ADDENDUM NO. 1

The following attached changes are incorporated into requirements for the Project No. 33-SBC-1001 Contract Documents by this Addendum:

KITTITAS RECLAMATION DISTRICT

SOUTH BRANCH CANAL IMPROVEMENTS

PLOT SCALE: 1" = 10'-0" DATE: 08-11-2020 SHEET SIZE: ANSI FULL BLEED D (22.00 X 34.00 INCHES) FILE NAME: CG302.DWG

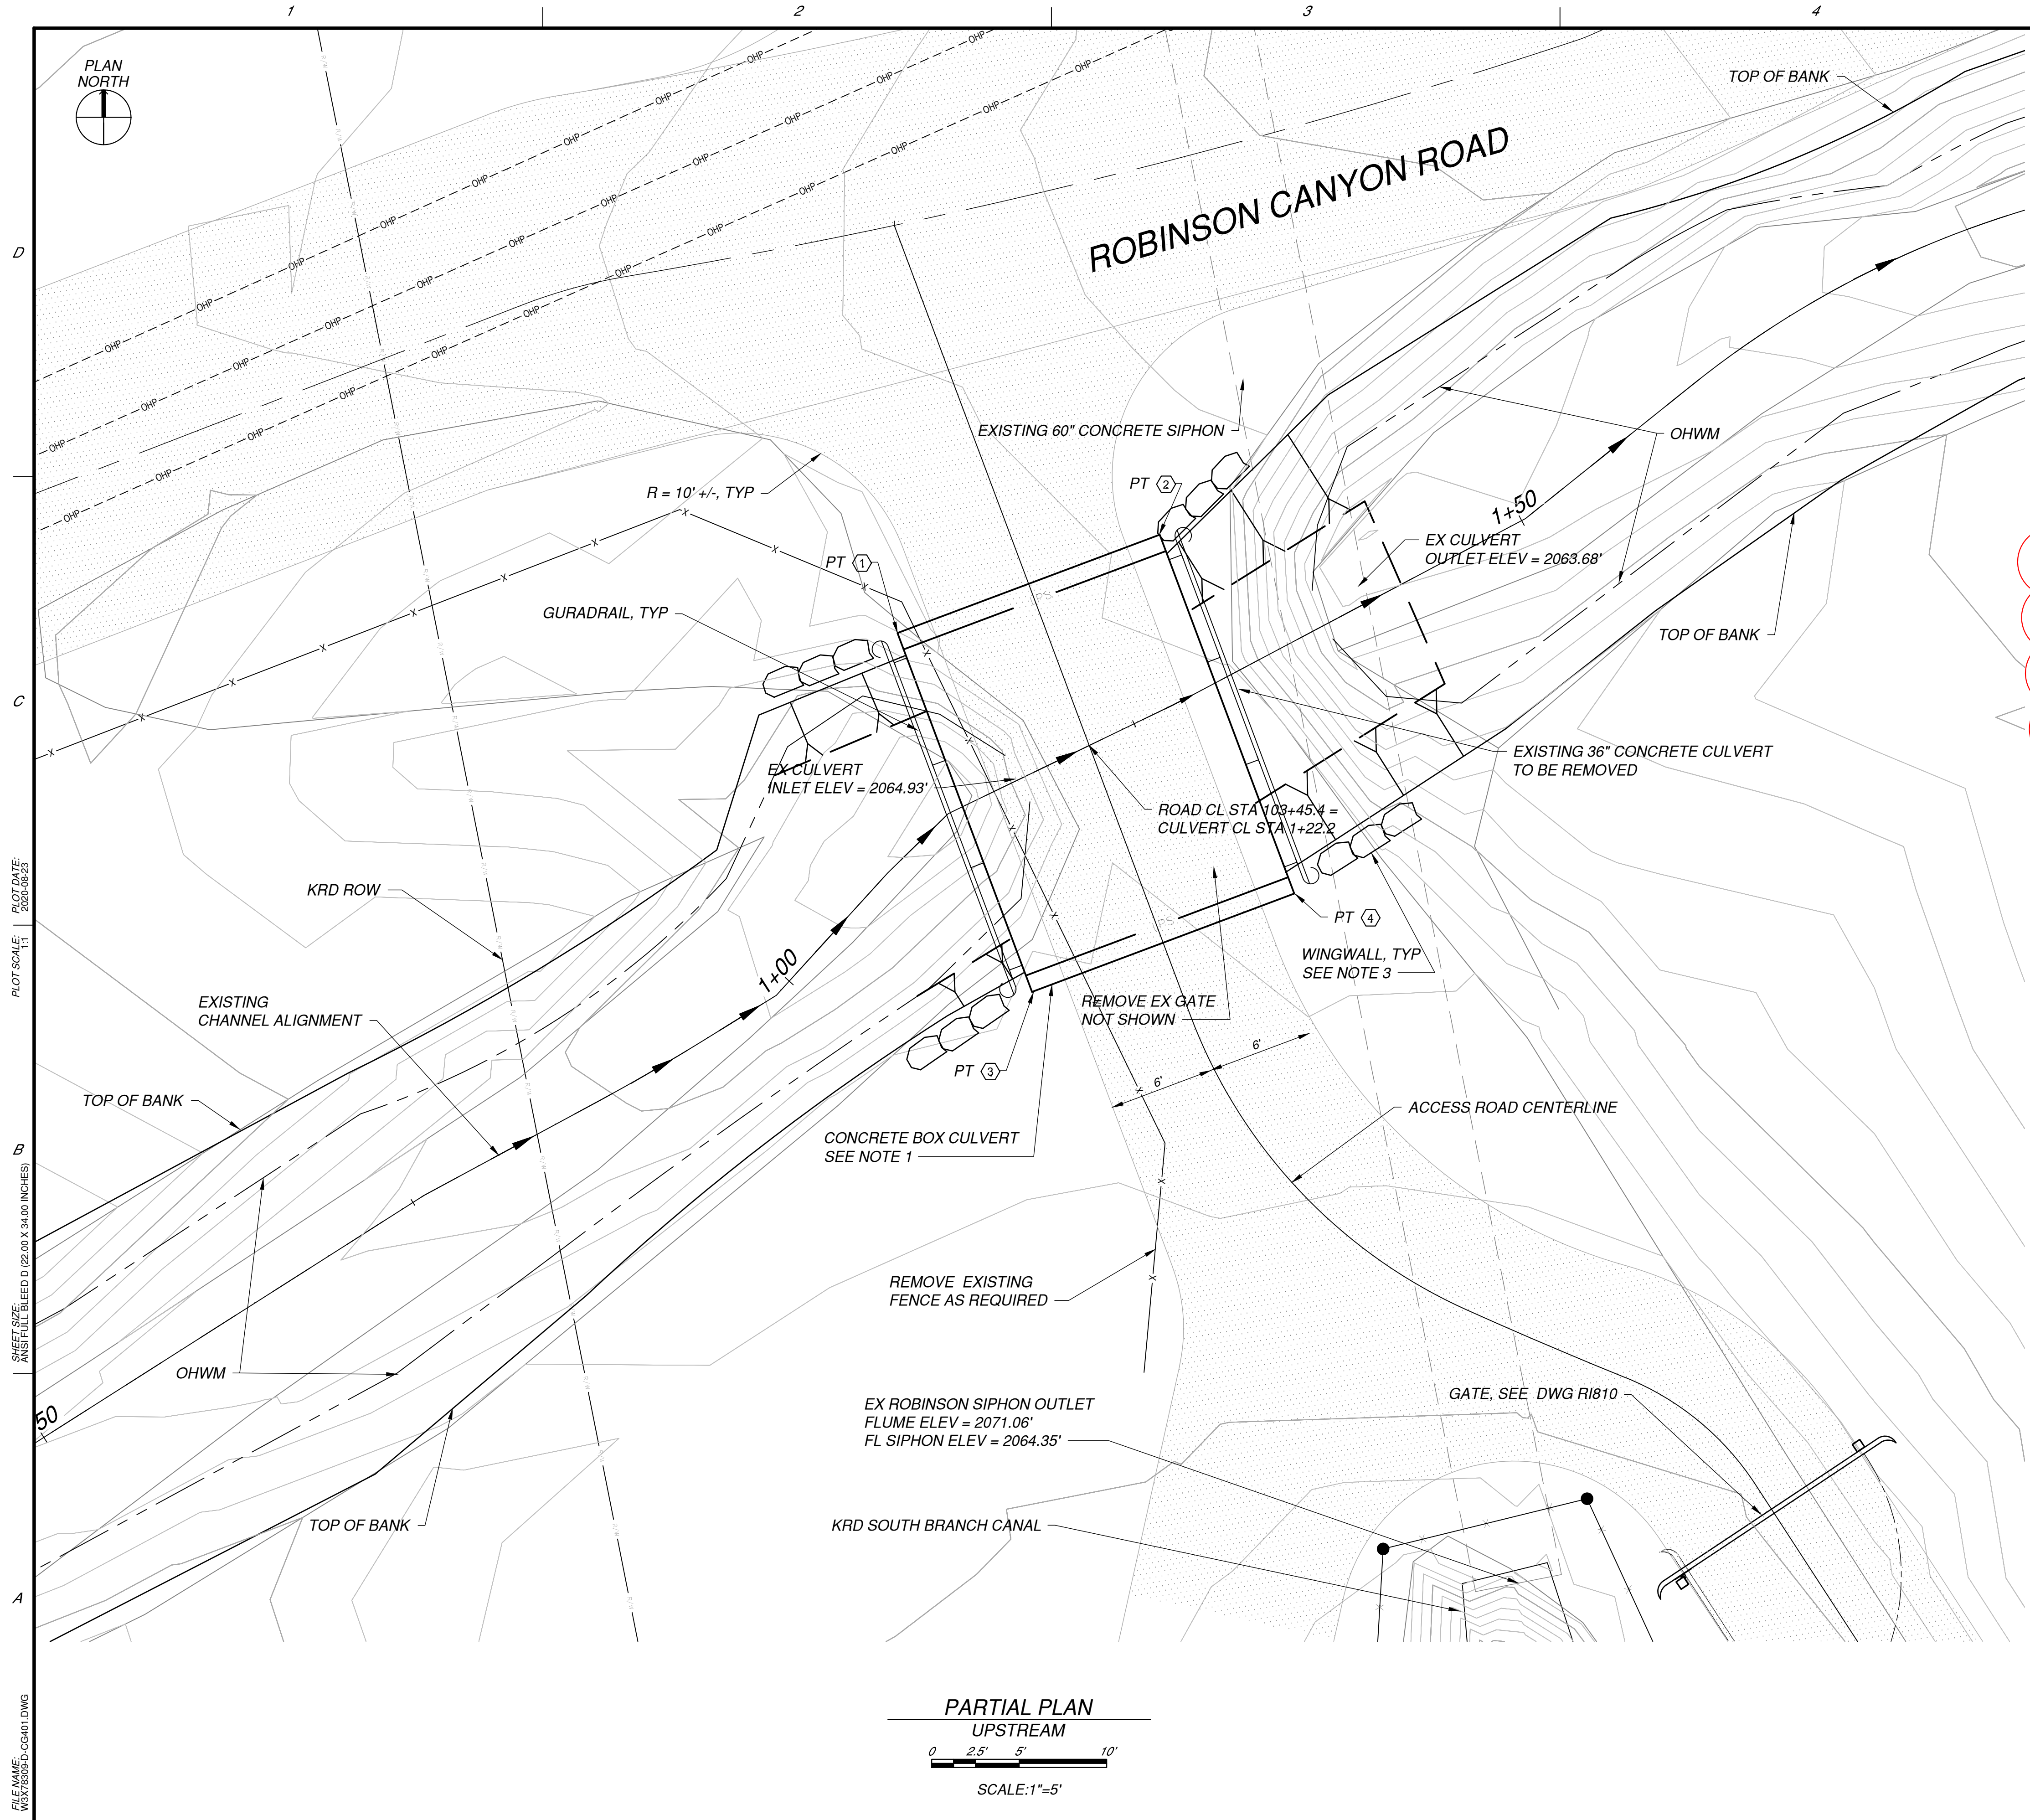
- f. Drawing CG301: Revised trench backfill material to utilize “Gravel Backfill”.
 - g. Drawing CG302: New sheet clarifying CDF backfill for thrust blocking and typical trench backfill material for alternative pipe material.

- INVERT OF ALL PIPES MEET SAME ELEVATION.
 - AT PIPE BENDS, PIPES TO BE BACKFILLED UP TO SPRINGLINE WITH CDF AS INDICATED ON DRAWING AND PROFILES. CONTRACTOR TO USE TIE DOWN ANCHORS OR OTHER MECHANISM TO GUARD AGAINST FLOTATION OF PIPE DURING INSTALLATION OF CDF.

CG401

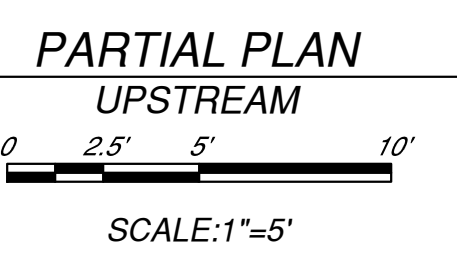
- h. Drawing CG401: Added coordinate points for box culvert orientation.
 - i. Drawing CG402: Revised notes and streambed material gradation based Washington Department of Fish & Wildlife permit review comments.

CG410
 SHEET 22 OF 34

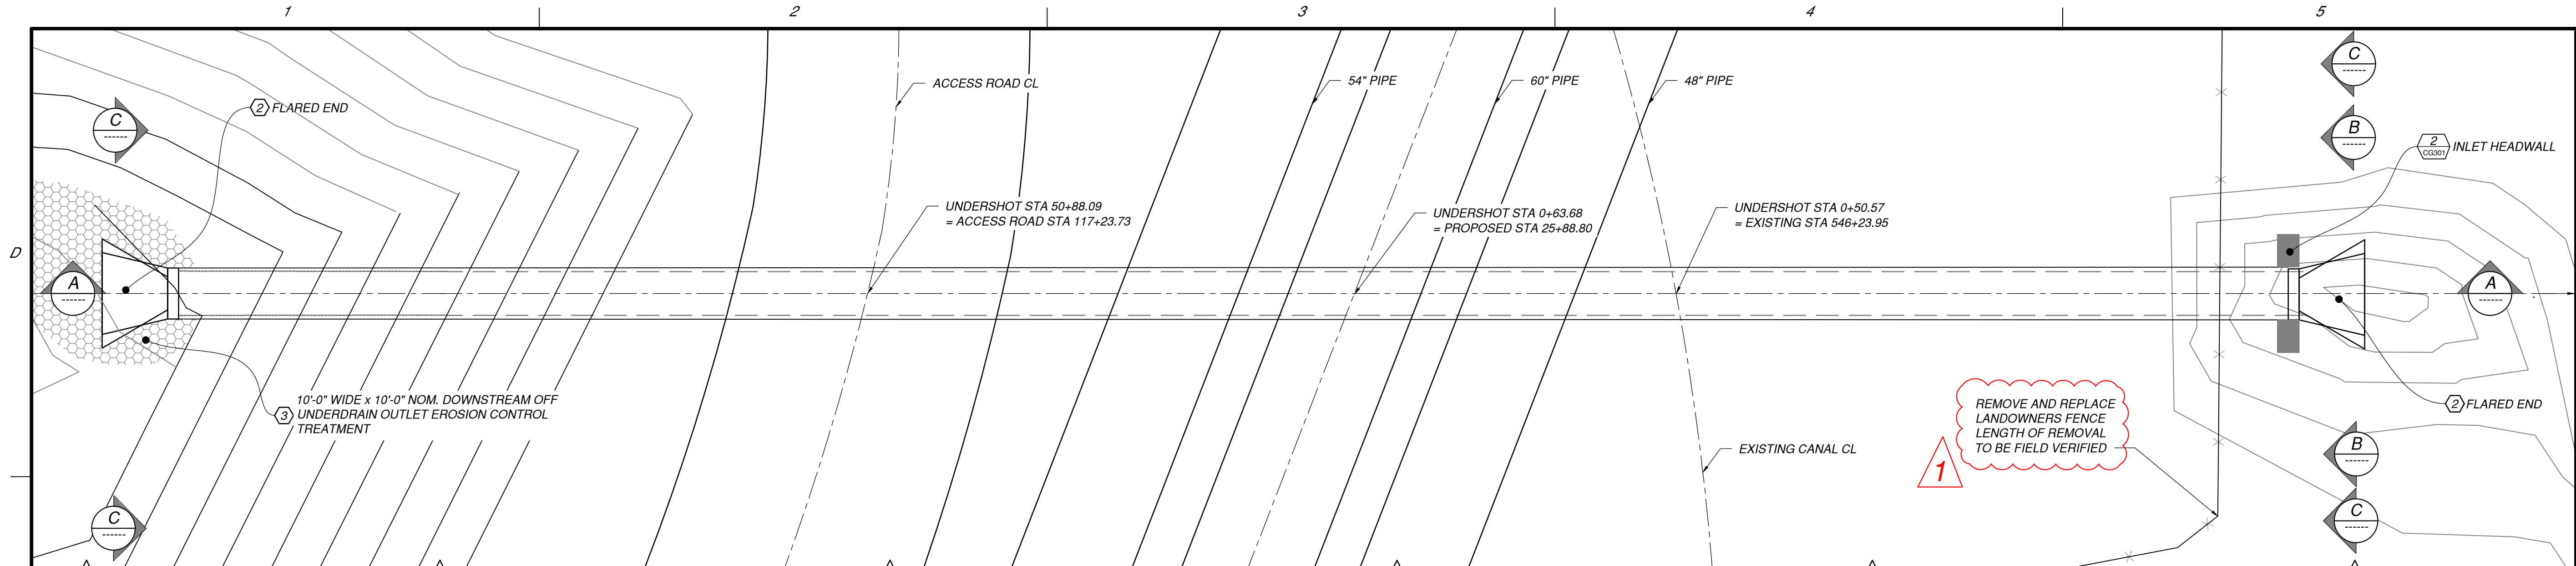
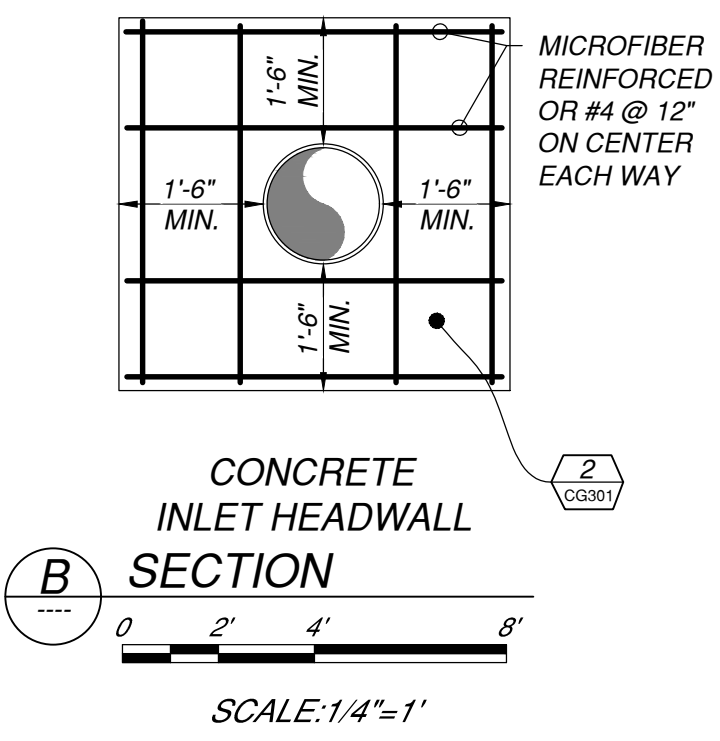
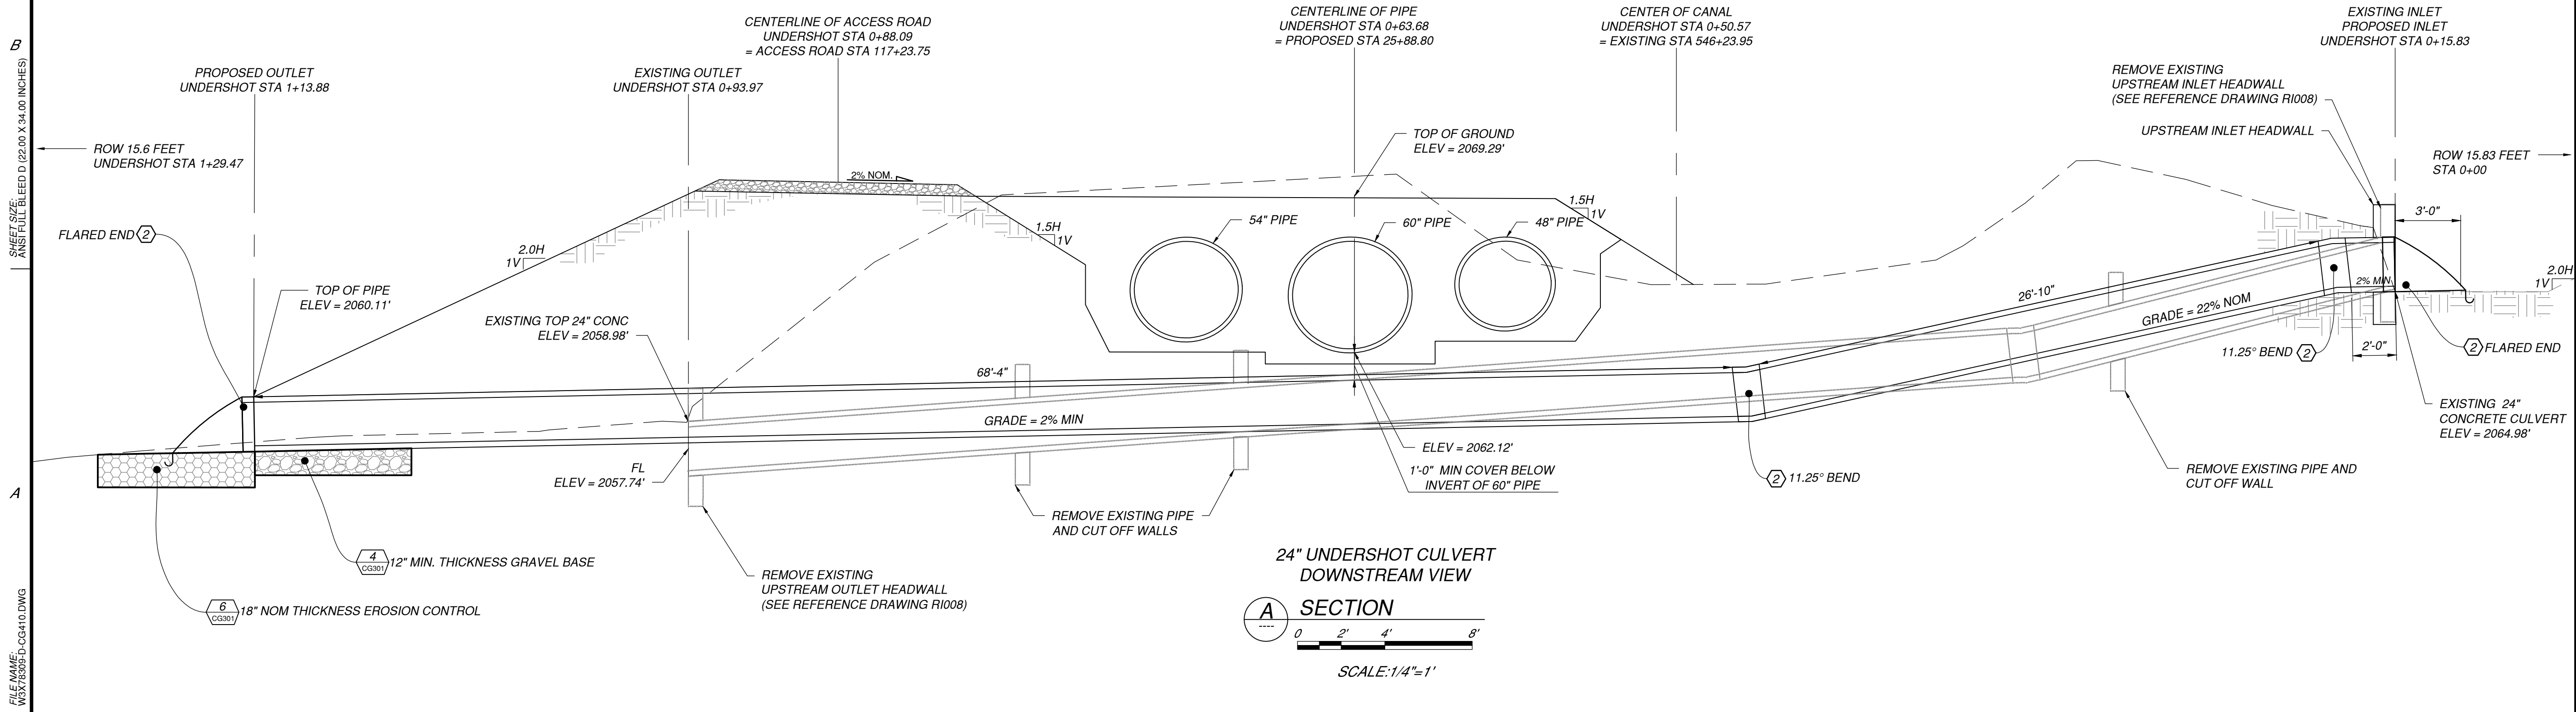
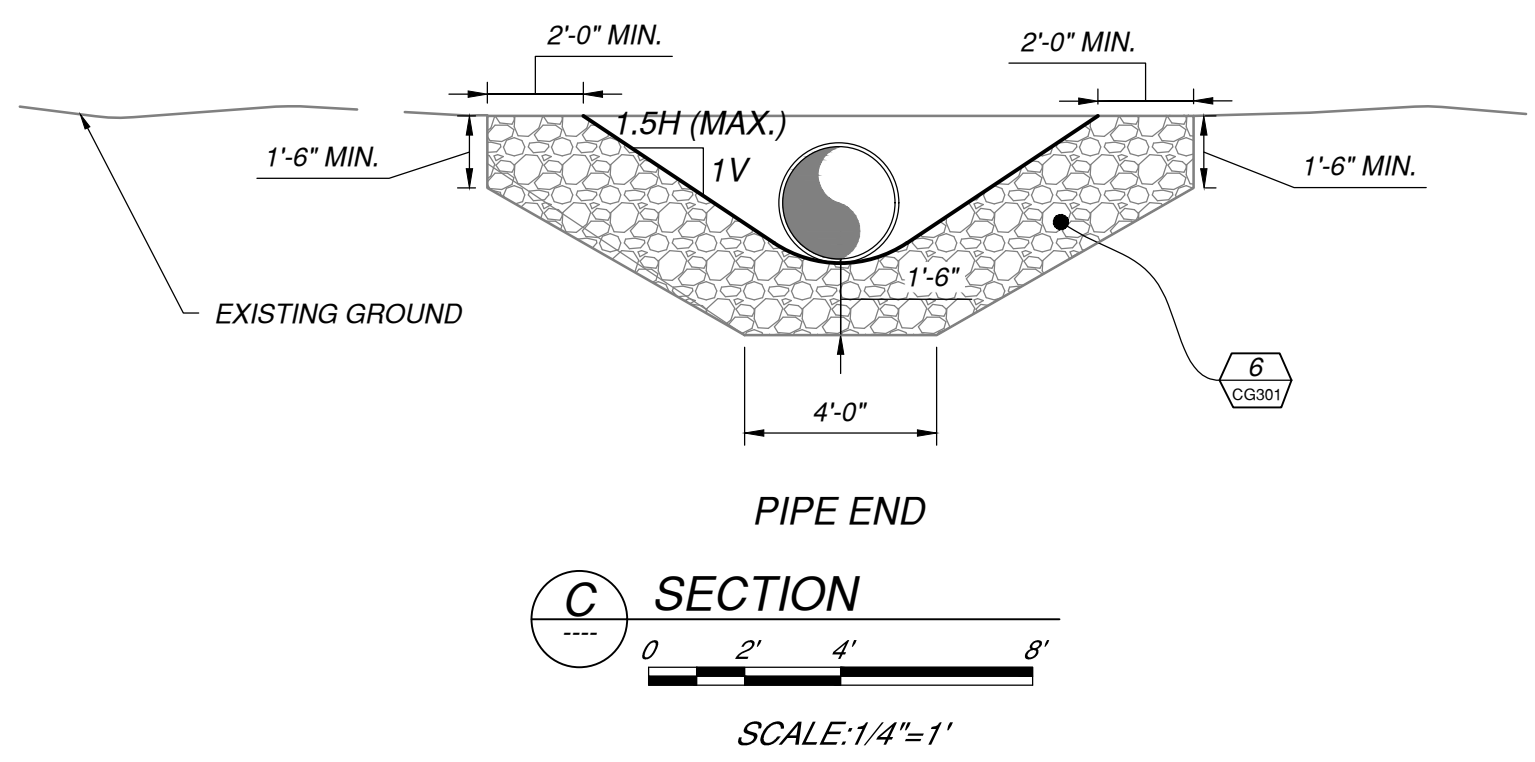
- j. Drawing CG410: Clarified need for restoring adjacent landowner fence on KRD property where access required for undershot culvert inlet replacement.
